STAFF RECOMMENDATION 200 Ensworth Avenue April 17, 2019

Application: New Construction—Infill
District: Woodlawn West Neighborhood Conservation Zoning Overlay
Council District: 24
Map and Parcel Number: 11604029800
Applicant: Chris Goldbeck, P. Shea Designs
Project Lead: Melissa Baldock, melissa.baldock@nashville.gov

Description of Project: Application is to construct infill and an outbuilding on vacant lot.

SITE PLAN
1:40

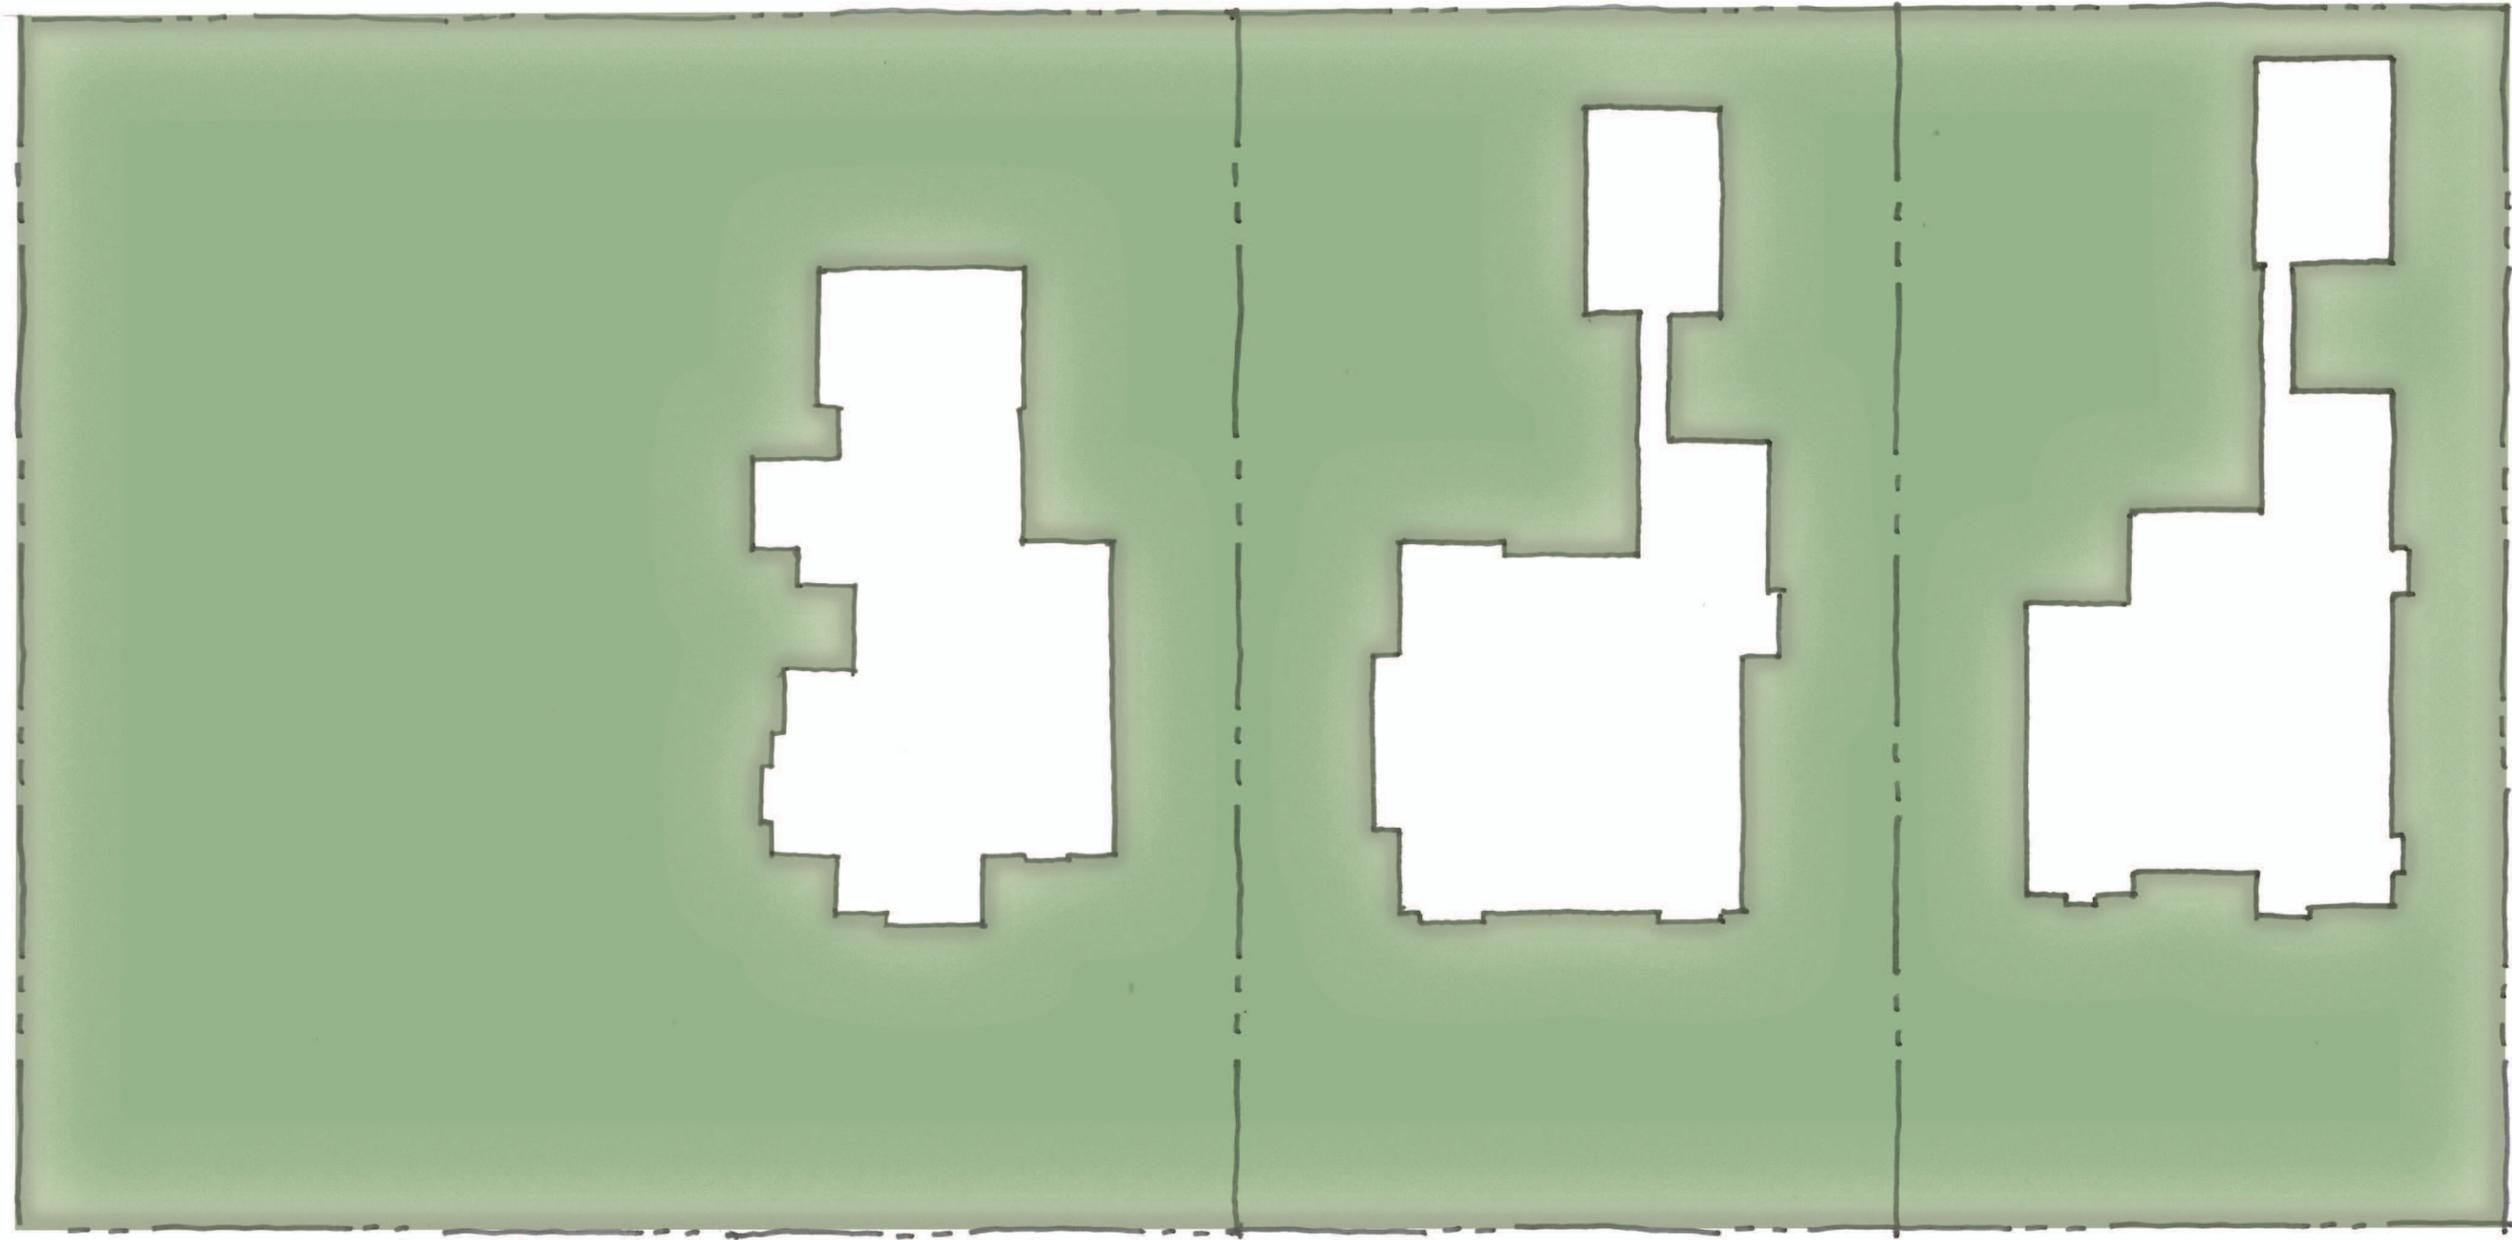
Setback & Rhythm of Spacing: The infill meets all base zoning setbacks. The setback along Woodlawn will be approximately fifty feet (50') and will line up with the infills previously approved at 3960 Woodlawn and 145 Montgomery Bell, which is appropriate. The setback along Ensworth Avenue will be one hundred and twenty feet (120'). This is over twenty feet (20') forward of the nearest house, 148 Ensworth Avenue. However,

because the lot at 148 Ensworth is four hundred feet (400') deep and the lot at 200 Ensworth is two hundred feet deep (200'), it is not practical for the house at 200 Ensworth to match the setback of the lot at 148 Ensworth Avenue. Staff finds the proposed Ensworth setback to be appropriate.

The infill will be forty-one feet, four inches (41'4") from the property line it shares with 148 Ensworth and twenty-feet, three inches (20'3") from the property line it shares with 3960 Woodlawn Avenue.

Staff finds that the proposed setbacks and rhythm of spacing meet Section II.B.1.c. of the design guidelines.

ENSWORTH ELEVATION
 SCALE: 1/4" = 1'-0"

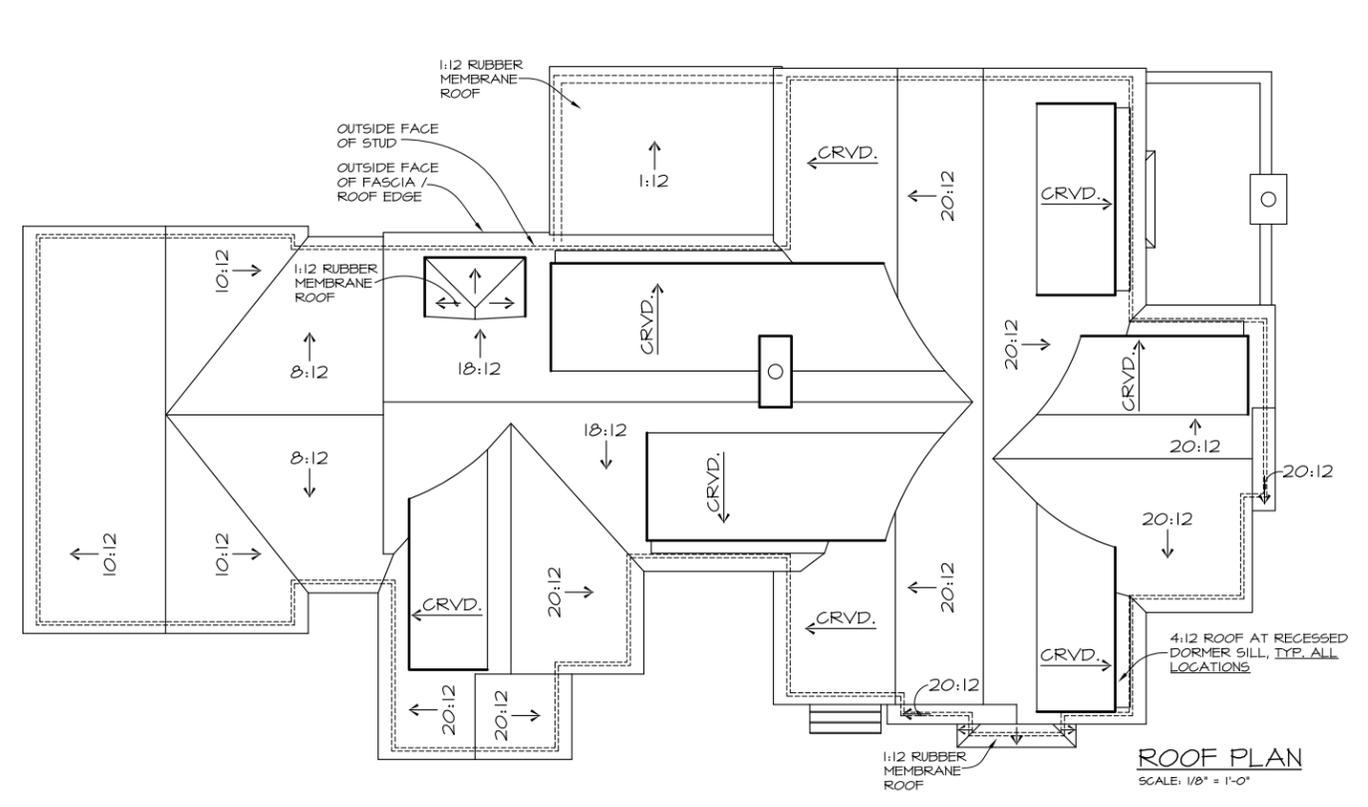
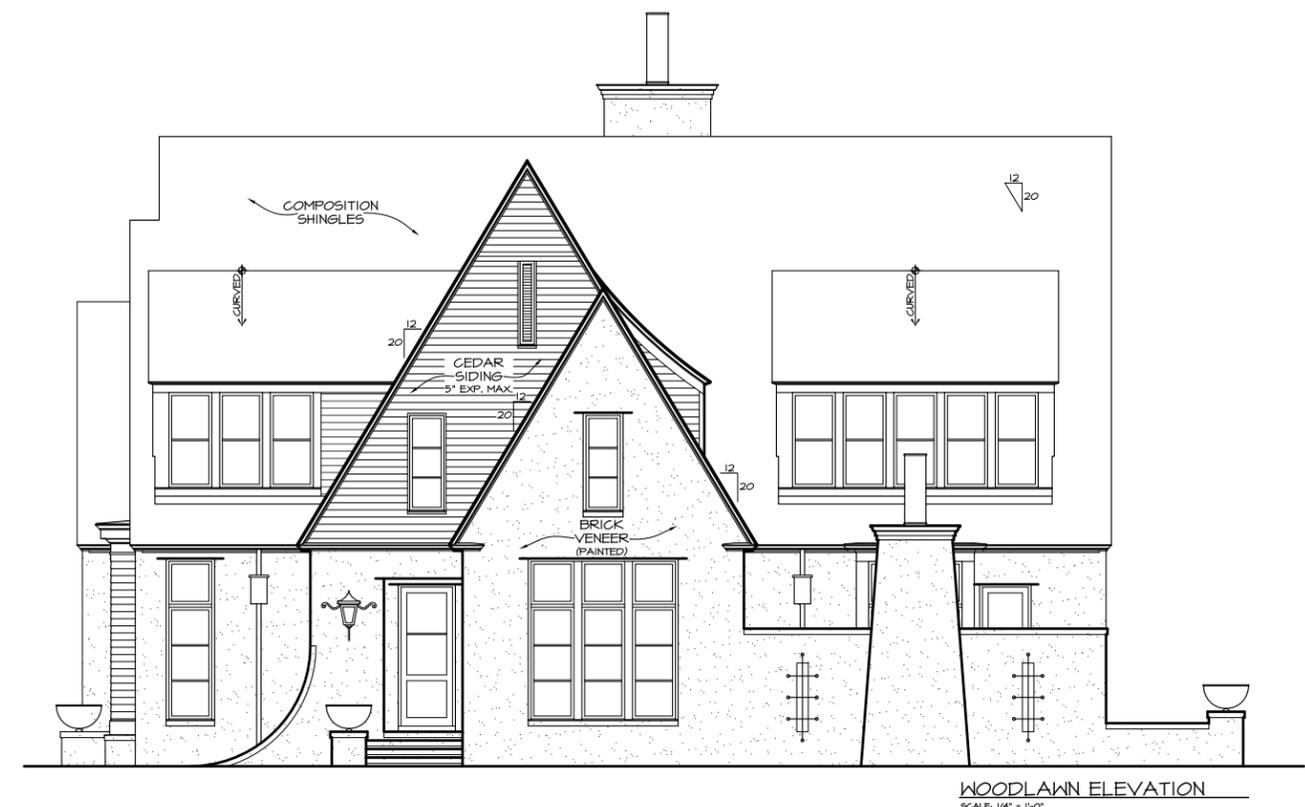
Height & Scale: The proposed infill is one-and-a-half stories in height, which meets the historic context. The historic houses along Kimpalong Avenue are largely one and one-and-a-half stories in height and the historic houses along Ensworth Avenue are largely two-stories in height. The maximum ridge height of the infill is thirty-six feet, eight inches (36'8"). Staff finds this to be appropriate, as the historic houses along Ensworth Avenue range in height from nineteen to thirty-six feet (19'-36'). The eave height of the infill is approximately nine feet, six inches (9'6").

Roof form: The infill's primary roof form is a cross gable. The gable pitches vary between 8/12 and 20/12. The front and side dormers have curved shed forms and are all inset a minimum of two feet (2'), as is required.

Proportion and Rhythm of Openings: The windows on the proposed infill are all at least twice as tall as they are wide, thereby meeting the historic proportions of openings. There are no large expanses of wall space without a window or door opening. All double and triple window openings have four to six inch (4"-6") mullions in between them.

**Staff recommends that the cedar siding be smooth and not rough sawn.

***Staff recommends that the stairs and floors of the front and side stoops be concrete or wood. Brick is not an appropriate material for the stairs and floors.

Appurtenances & Utilities: The location of the HVAC and other utilities was not noted. Staff recommends that the HVAC be located on the rear façade, or on a side façade beyond the midpoint of the house.
